UNITED STATES PATENT AND TRADEMARK OFFICE

09/933,379

Office Action Summary	Application No. 09/933,379	Applicant(s) MARR, KEN W.	
	Examiner MATTHEW W. SUCH	Art Unit 2891

DETAILED ACTION

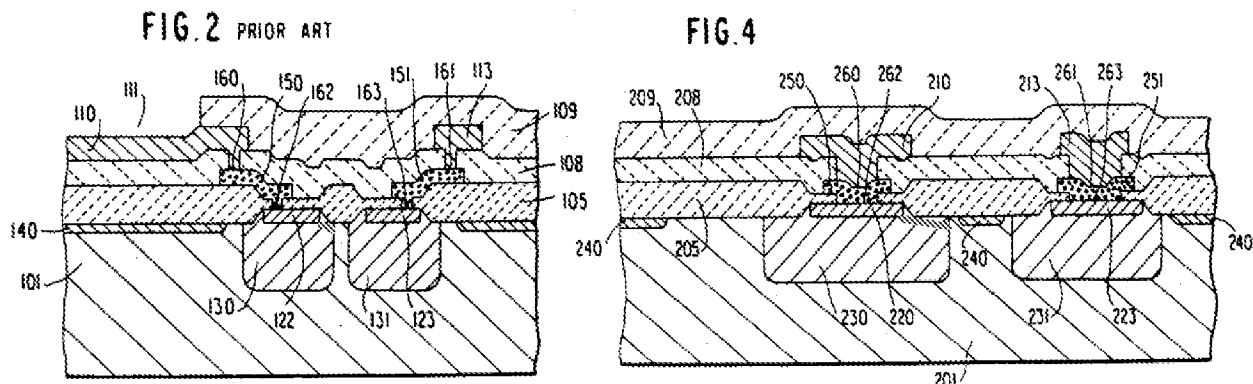
6. Regarding claim 37, Yamamura teaches a method comprising forming a first doped well (Element 130, Fig. 2 or Element 230, Fig. 4) in a first doped region (Element 101, Fig. 2 or Element 201, Fig. 4). A first doped plug (Element 122, Fig. 2 or Element 220, Fig. 4) is formed within the first doped well. The first doped plug is formed a first distance from a first boundary of the first doped well ("grey" line added to Figs. 2 and 4 for clarity):

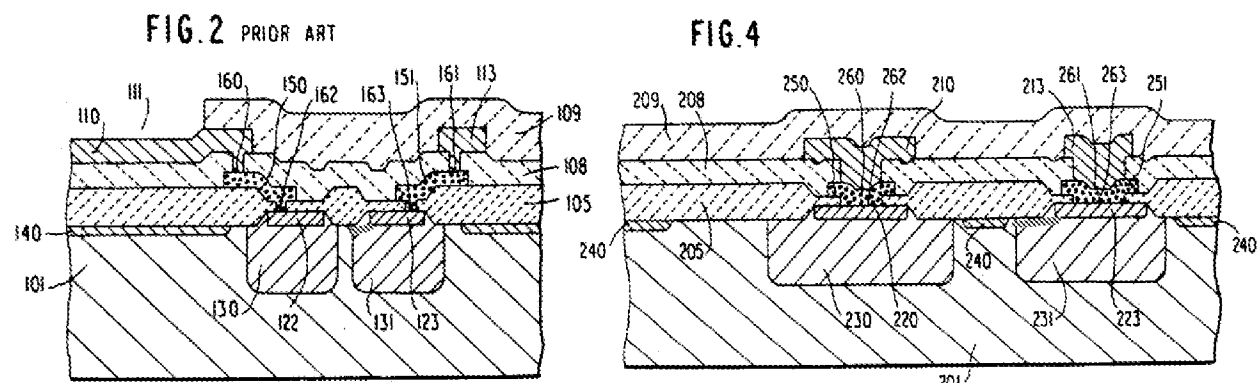
7. Regarding claim 36, Yamamura teaches a second doped well (Element 131, Fig. 2 or Element 231, Fig. 4) formed within the first doped region. The second doped plug is formed a second distance from a second boundary of the second doped well ("grey" line added to Figs. 2 and 4 for clarity):

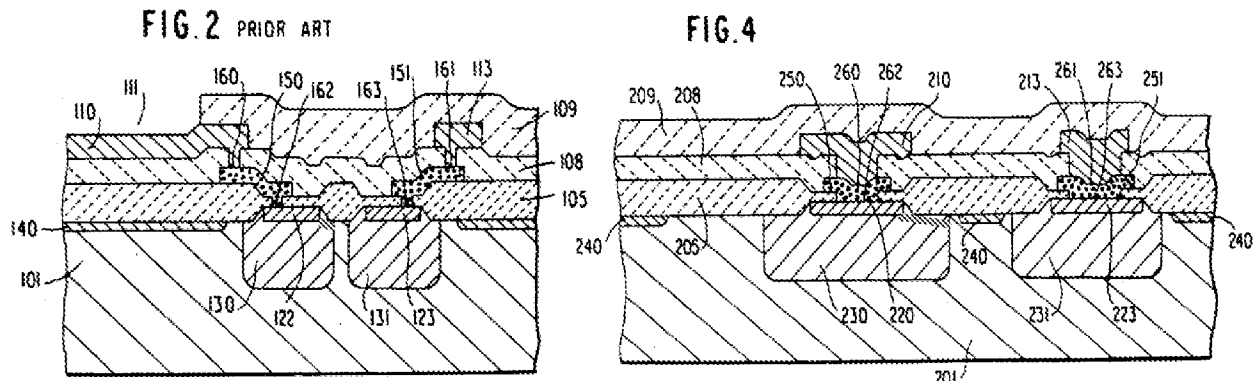
Line 52 or Col. 6, Lines 26-27). A first n-plug (Element 122, Fig. 2 or Element 220, Fig. 4; Col. 5, Line 56; Col. 6, Lines 31-32 and 59) is formed within the first n-well. The first doped plug is formed a first distance from a first boundary of the first doped well ("grey" line added to Figs. 2 and 4 for clarity):

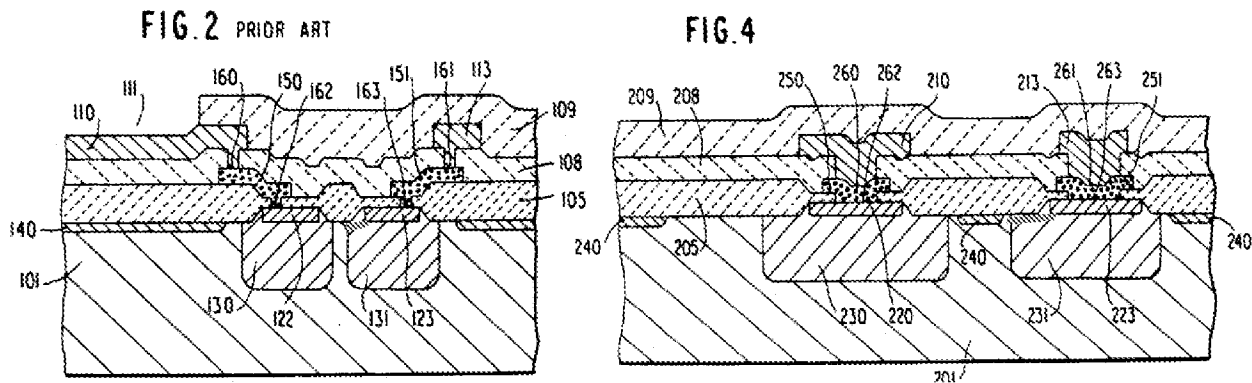
12. Regarding claim 45, Yamamura teaches a second n-well (Element 131, Fig. 2 or Element 231, Fig. 4; Col. 5, Lines 54-55 or Col. 6, Lines 25-26, for example) formed within the p-type semiconductor substrate. The second n-plug is formed a second distance from a second boundary of the second n-well ("grey" line added to Figs. 2 and 4 for clarity):

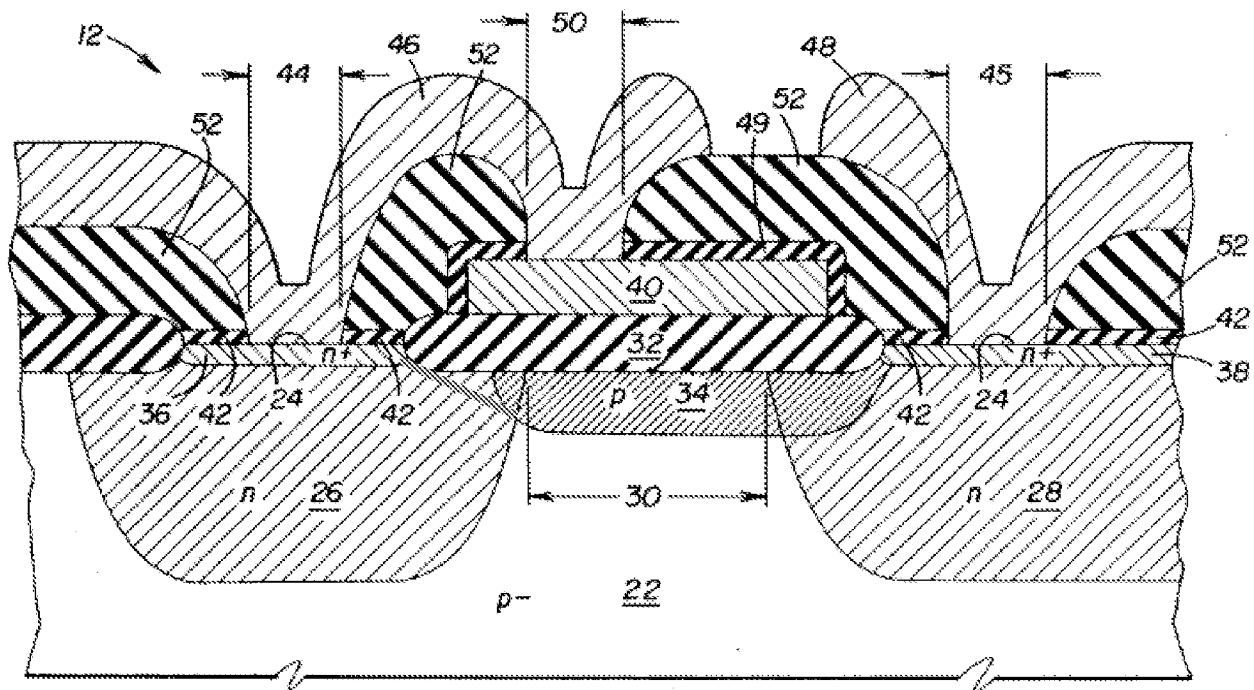
17. Regarding claim 37, Longcor teaches a method comprising forming a first doped well (Element 26) in a first doped region (Element 22). A first doped plug (Element 36) is formed within the first doped well. The first doped plug is formed a first distance from a first boundary of the first doped well ("grey" line added to Figs. 3 or 4, at least):

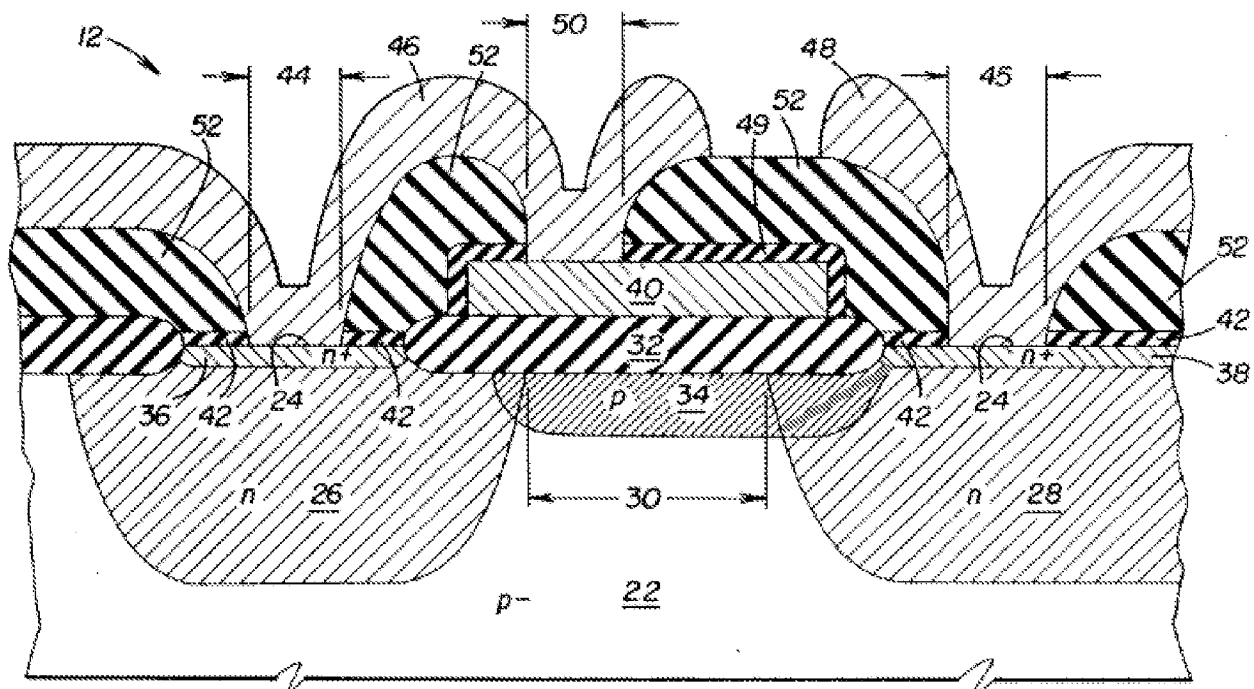
18. Regarding claim 36, Longcor teaches a second doped well (Element 28) formed within the first doped region. The second doped plug is formed a second distance from a second boundary of the second doped well ("grey" line added to Figs. 3 or 4, at least):

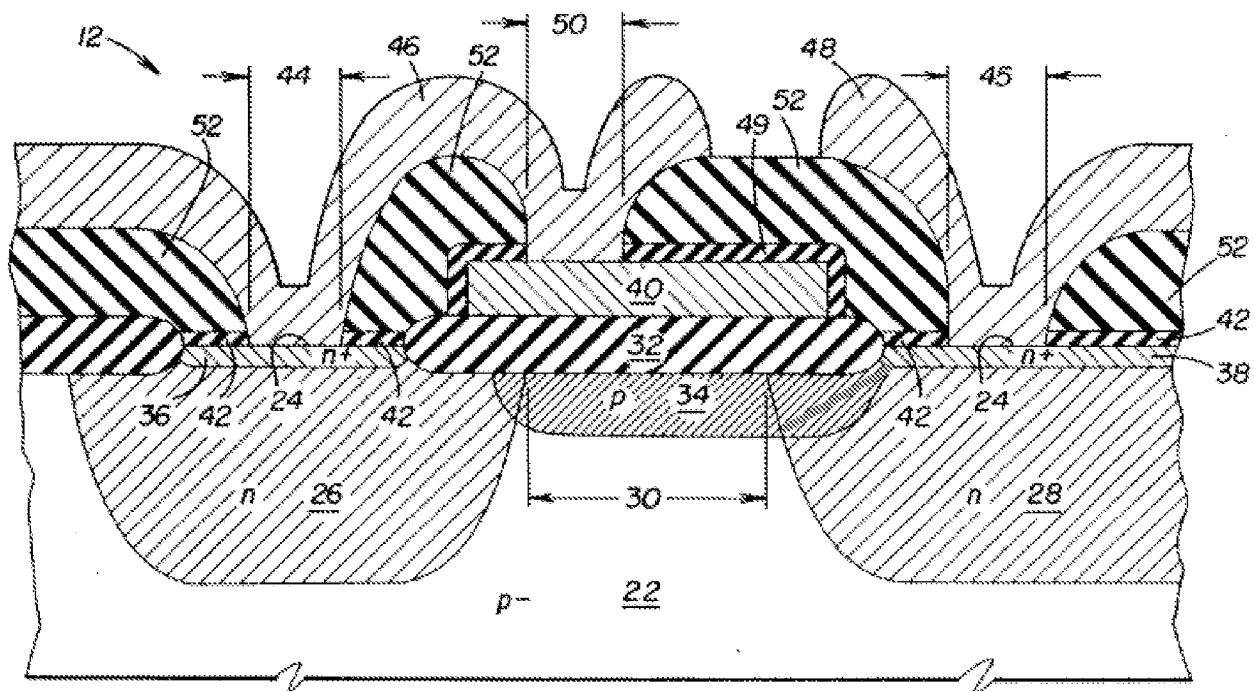
22. Regarding claim 46, Longcor teaches a method comprising forming a first n-well (Element 26) in a p-type semiconductor substrate (Element 22). A first n-plug (Element 36) is formed within the first n-well. The first doped plug is formed a first distance from a first boundary of the first doped well ("grey" line added to Figs. 3 or 4, at least):
